Re: Bishop Tube Site
Response to DEP's July 10, 2017 E-mail Regarding
Supplemental Remedial Investigation Work Plan Modifications

PROPOSED SCOPE-OF-WORK		
FORMER BISHOP TUBE FACILITY CHESTER COUNTY, PENNSYLVANIA		
Prepared For: BISHOP TUBE PROJECT TEAM		
ROUX Environmental Consulting & Management	Compiled by: SSPR Prepared by: SSPR Project Mgr: JAK File No: 2136.F1(BL)	Date: 7/13/2017 Scale: 1:3,000 Office: NJ Project: 0539.0003.J000
		FIGURE 1

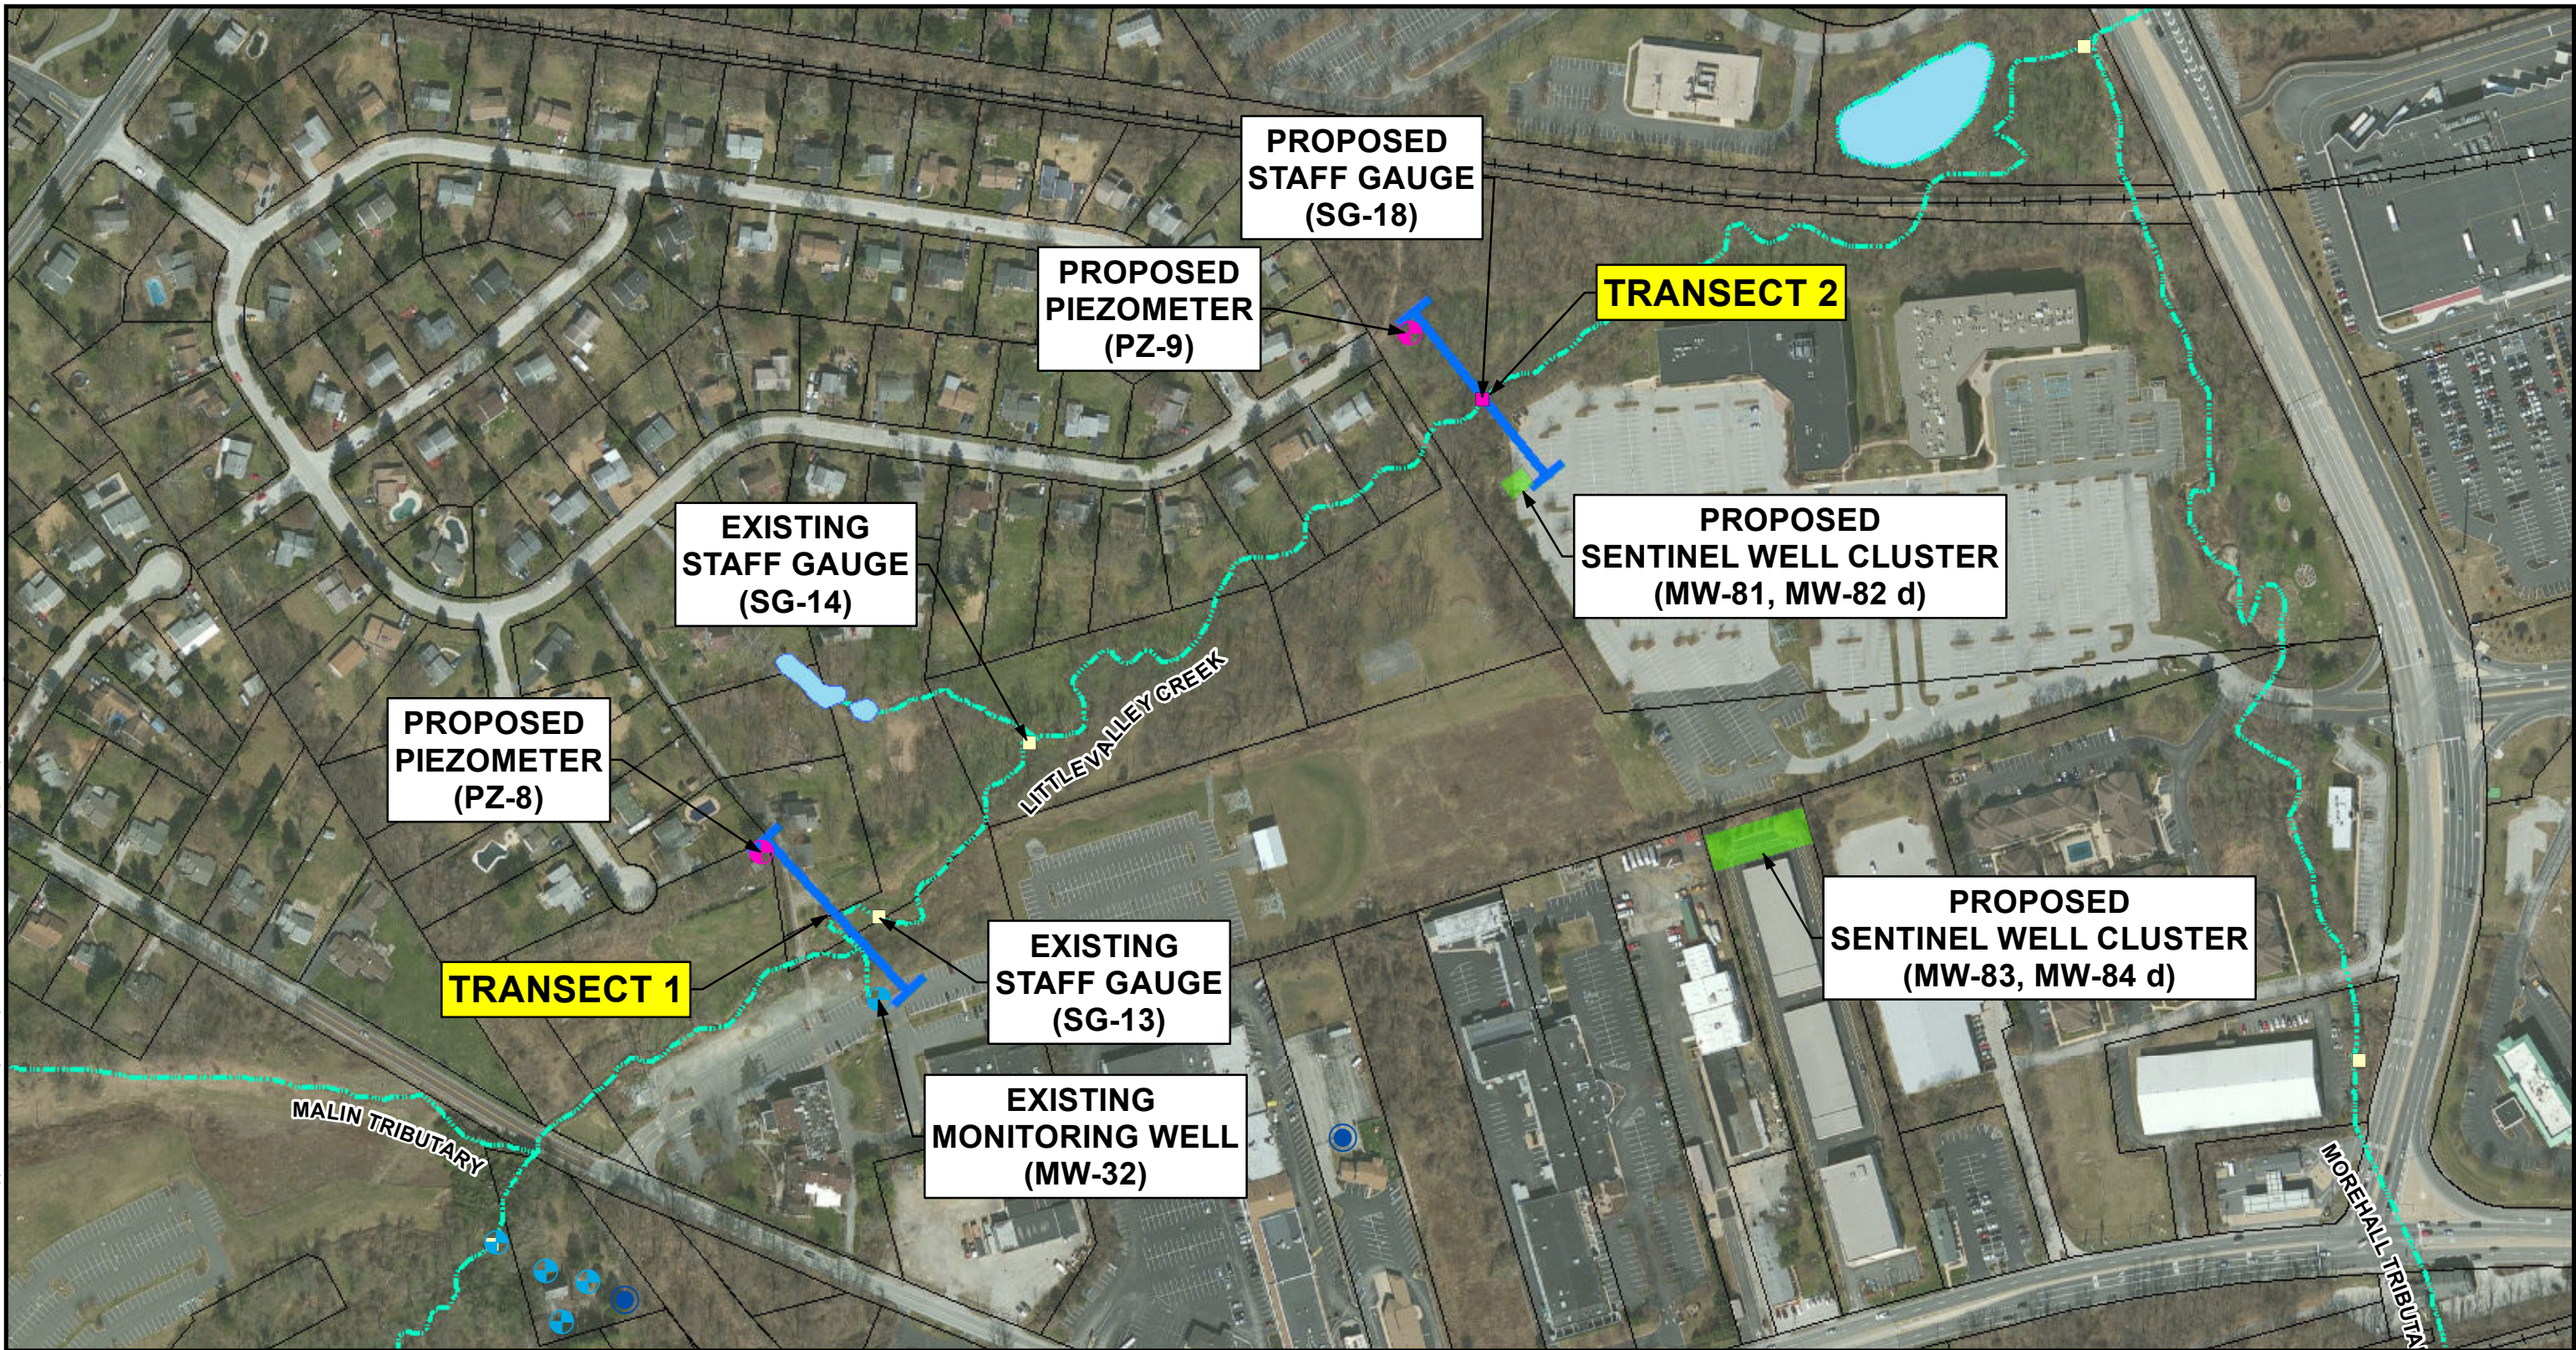
Item 2 - Proposed Revision to Transect 2 Location - As discussed with DEP via conference call on July 13, 2017, the proposed monitoring well and stream gauge locations along transect 2 have been moved slightly east as depicted on the attached figure. The purpose of the change is to avoid potentially lengthy access delays associated with the original transect location.
